CCO No.	Suppl. No.	Contract No.	Contract Name	Federal Number(s)
2		8597 Project No. 36204002	Patterson Drive Emergency Culvert Repair Project	NA

EL DORADO COUNTY
DEPARTMENT OF TRANSPORTATION
Contract Change Order

EXHIBIT C - DETAIL SHEETS (3 OF 4)

PATTERSON DRIVE EMERGENCY
 CULVERT REPAIR PROJECT

SHEET
P&D
 3 OF 4
 CONTRACT No.
8597

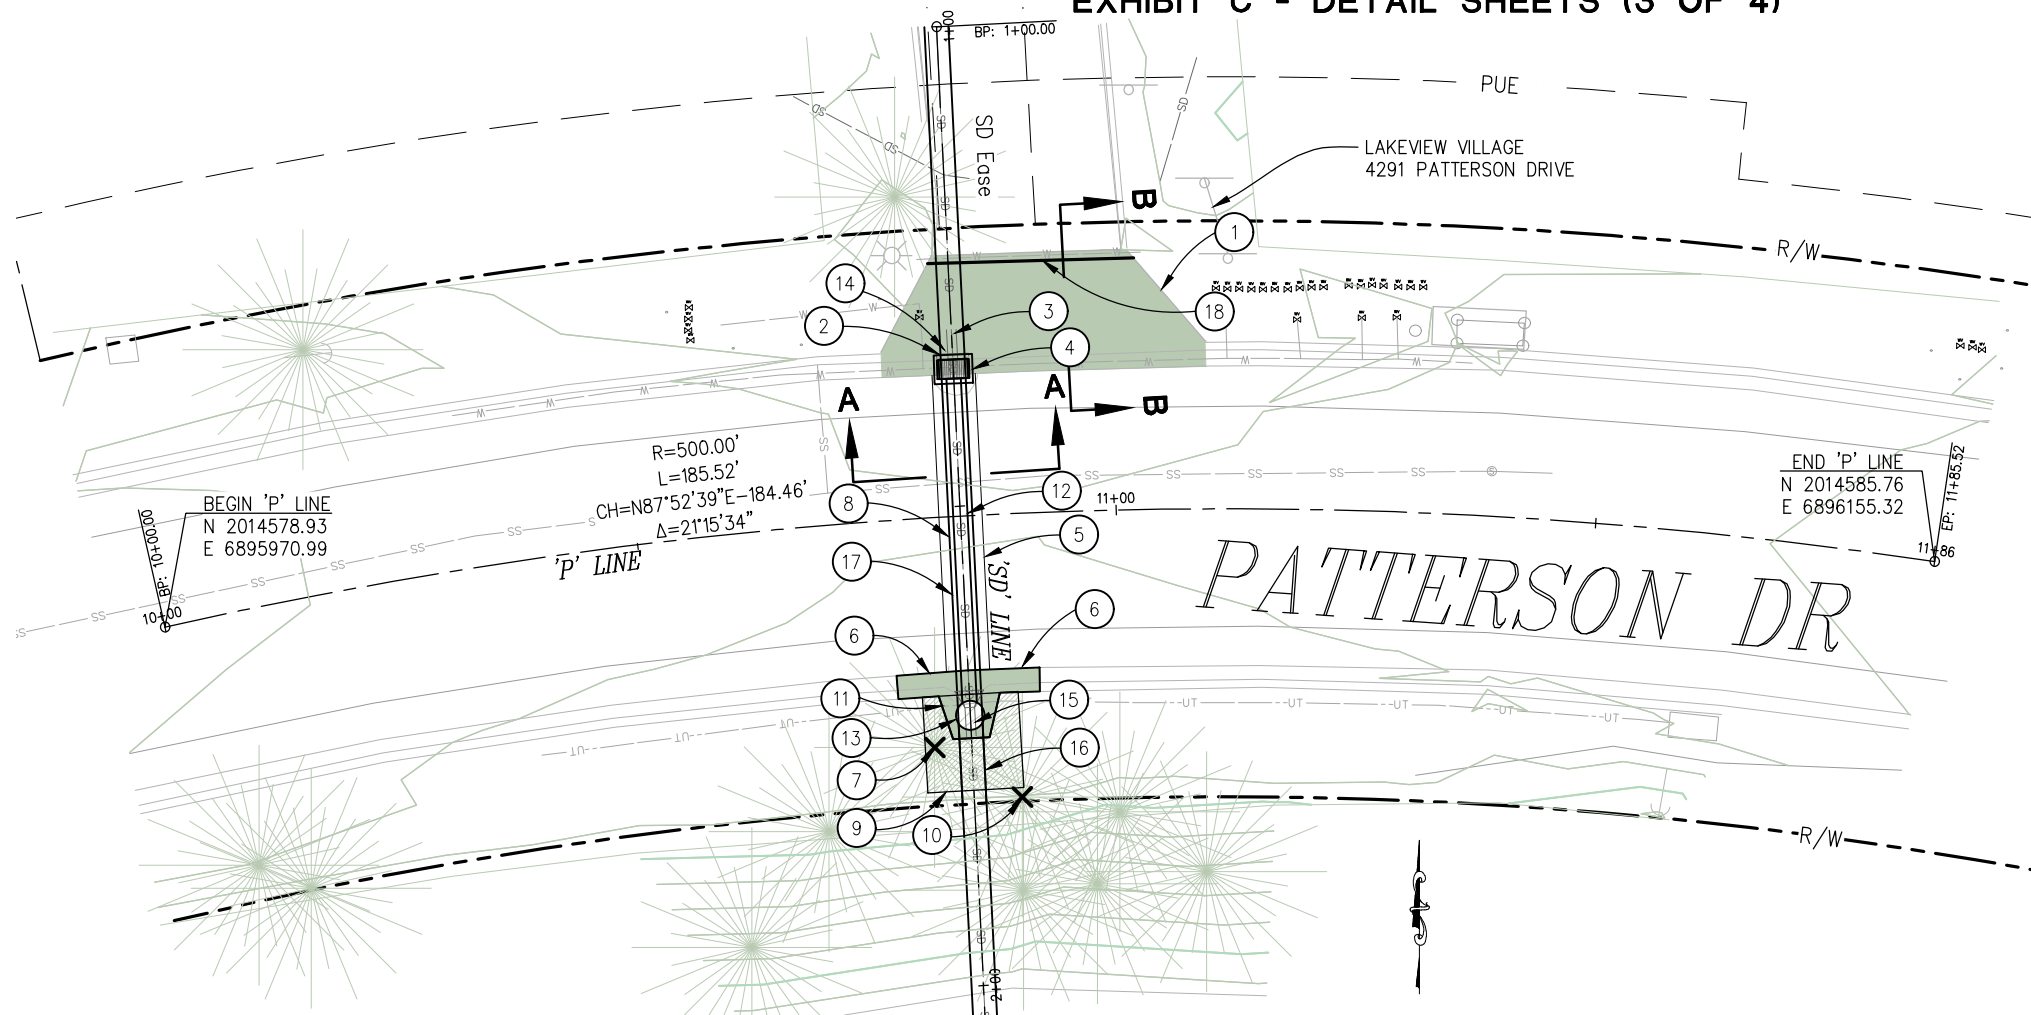
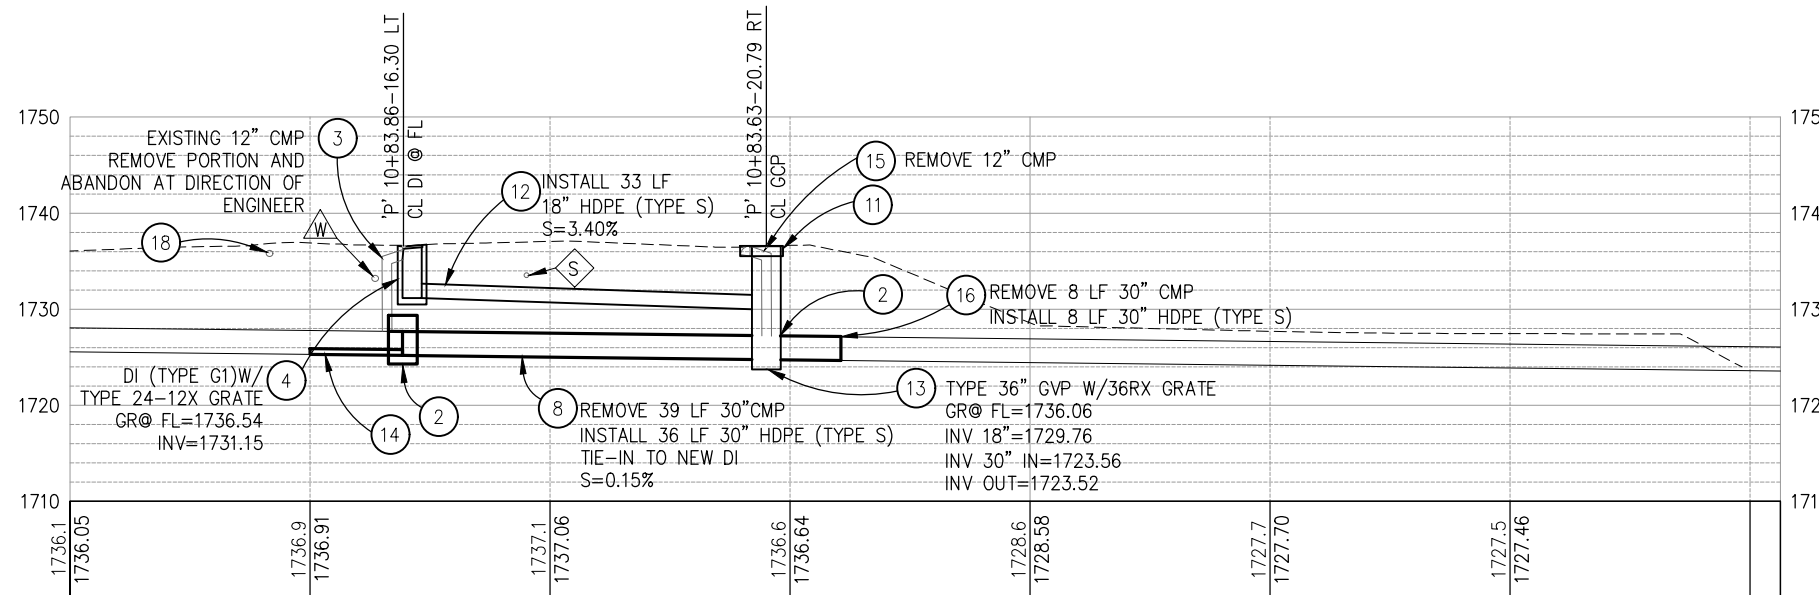
In accordance with Standard Specification 4-1.05, Changes and Extra Work, and as shown on sheets 3 and 4 of this Contract Change Order #2, revise the scope of the drainage system installation to extend the drainage system west from the CCO1 GCPI inlet to the County Right of Way and perform additional Pipe Removal and 30" Plastic Pipe installation as needed for the revised layout of drainage inlet revisions in CCO1. Perform additional Roadway Excavation, additional 30" Plastic Pipe installation, additional Pipe Removal, additional Culvert Slurry-Cement Backfill, and eliminate installation of the Rolled Erosion Control Product (Netting) at the following agreed quantities and Bid Item Prices:

- CC03 - COVER DISTURBED GROUND WITH LEAF MULCH AND CHIP STOCKPILED PRIOR TO EXCAVATION.
- CC02 - REMOVE 12" DBH OAK TREE AND ROOT BALL.
- CC01 - TIE-IN CONCRETE APRON AND 6" CURB AND GUTTER.

- REMOVE EXISTING 12" CMP.
- CC02 - EXTEND 30" HDPE (TYPE S) 8 LF FROM GCP TO R/W - COUPLE AT R/W TO 30" HDPE REPLACEMENT (BY OTHERS).
- SEE CD SHEET FOR DRAINAGE SYSTEM DETAILS.

SHEET	CD
	4 OF 4
CONTRACT No.	8597

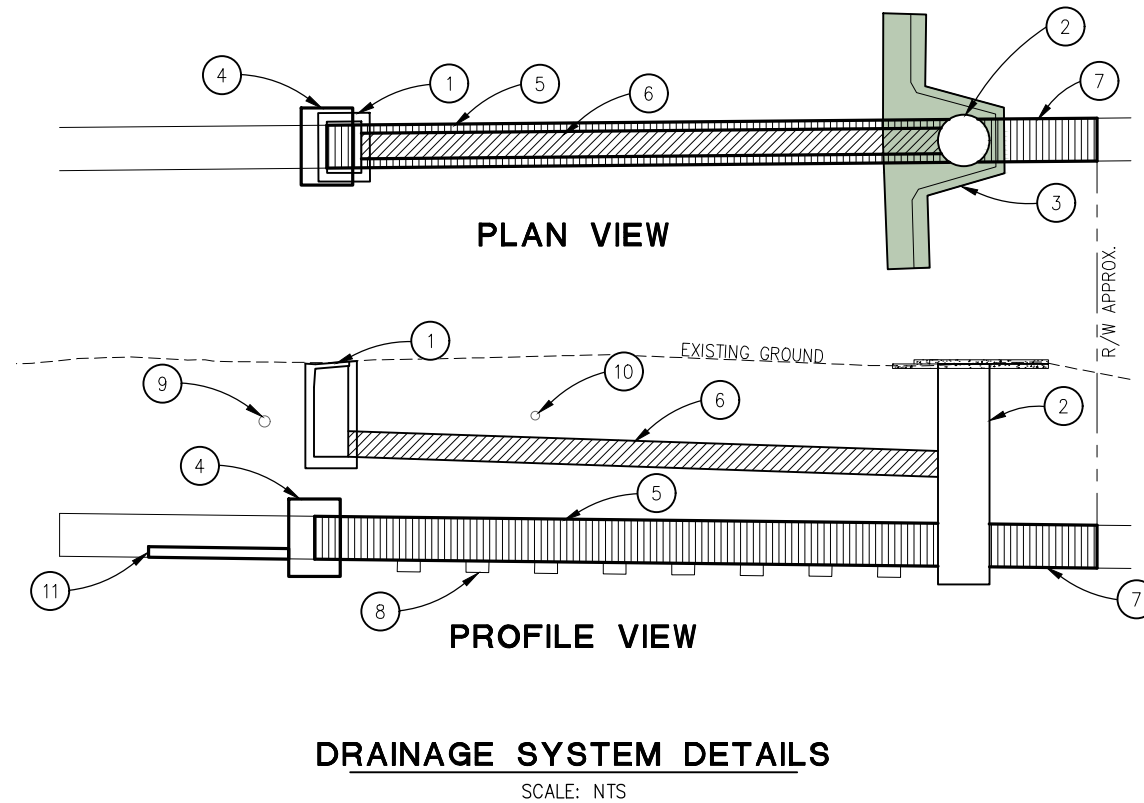
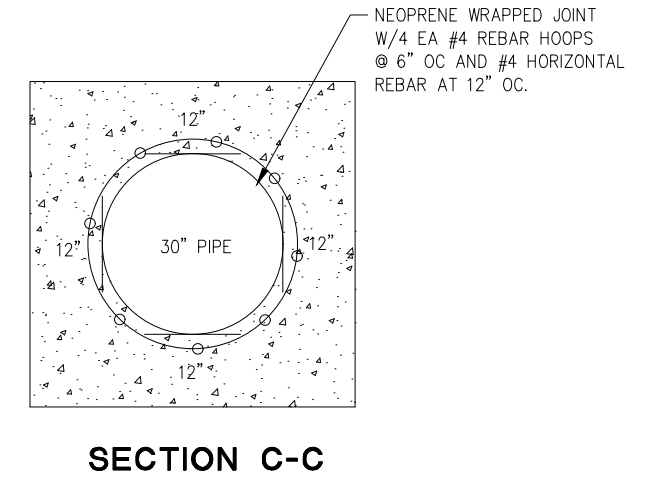
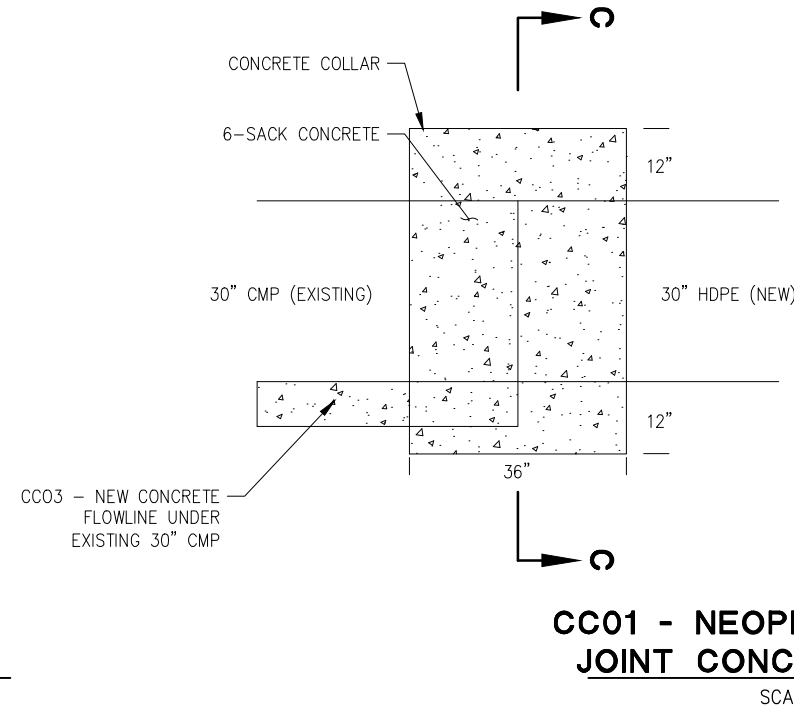
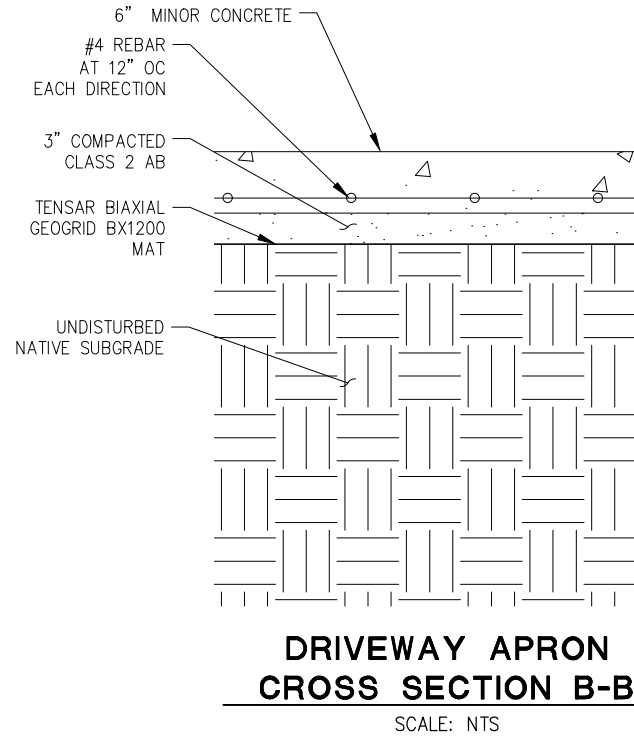
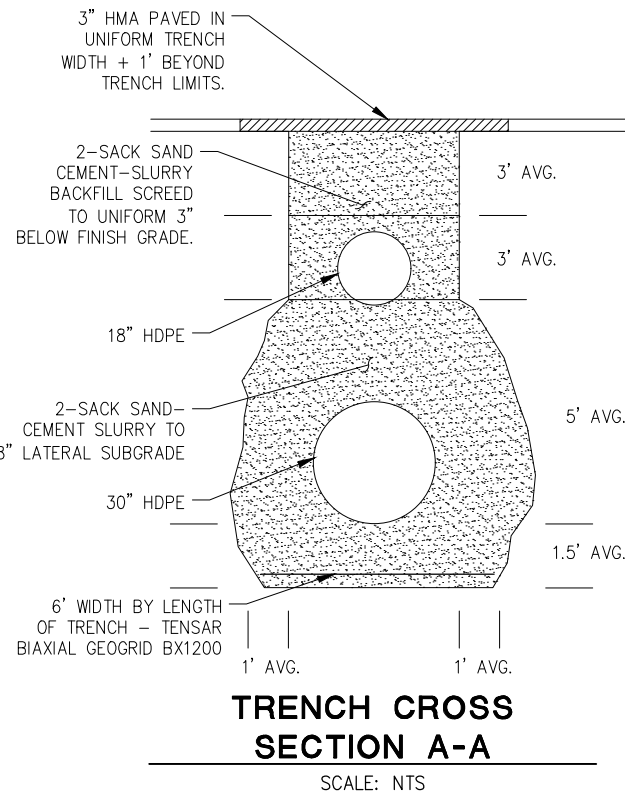
- 7 - CC02 - NEW 30" HDPE (TYPE S) WITH WATER TIGHT JOINTS. EXTEND 8 LF TO R/W. MATCH EXISTING 0.15% SLOPE. COUPLE TO ADJACENT 30" HDPE PIPE REPLACEMENT BEYOND R/W (BY OTHERS).

- 8 - CC03 - 2'X8"X16" BRICK EVERY 4' OC (TYPICAL). LOW SLUMP 2 SACK SAND SLURRY BACKFILL FROM BOTTOM OF 1.5' OVER EXCAVATION UNDER 30" HDPE TO 18" HDPE SUBGRADE - THEN 2-SACK SAND-CEMENT SLURRY FROM BOTTOM OF 18" HDPE TO 3" BELOW HMA FINISH GRADE.
